8101 Glenbrook Road, Preliminary Plan Amendment No. 12016001A and Site Plan Amendment No. 81981081A

Staff Report Date: 7/8/19

- Request to convert 21,200 square feet of office space to a child day care facility for up to 231 children.
- Current use(s): Office Uses
- Address: 8101 Glenbrook Road; Bethesda
- Size: 25,733 square feet of land
- Zone: CR 3.0, C. 3.0, R-3.0, H120, Bethesda Overlay Zone
- Master Plan: *2017 Bethesda Downtown Sector Plan*
- Applicant; MDR 8101 Ground Lease, LLC
- Acceptance date: October 5, 2018

Figure 2: Proposed Preliminary Plan Amendment and Site Plan Amendment

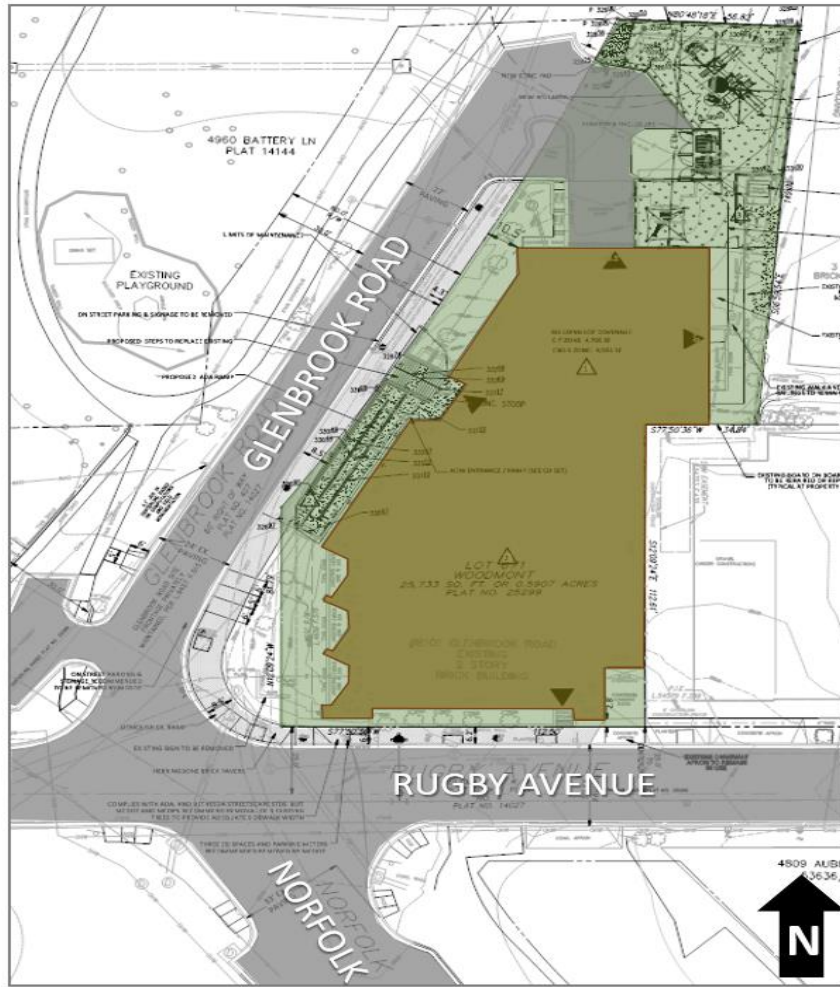
- b. Revise Data Table to show correct required open space requirement and provided open space requirements.
 - c. Revise Preliminary Plan to show removal of on-street parking spaces on Glenbrook Road.

- a. Include the stormwater management concept exemption letter and the Site Plan Amendment resolution on the approval or cover sheet(s).
- b. Revise Data Table to show the correct required open space requirement and provided open space requirement and show the entire fence that encloses the playground.
- c. Revise Site Plan to show removal of on-street parking spaces on Glenbrook Road.

The existing building's footprint will remain unchanged under this proposal. However, the existing 6-space parking surface lot at the site's northern boundary will be removed and replaced with an outdoor play area for the child care facility. The outdoor play area will be enclosed with a fence and supplemental landscaping along the eastern lot line to further screen the building and use.
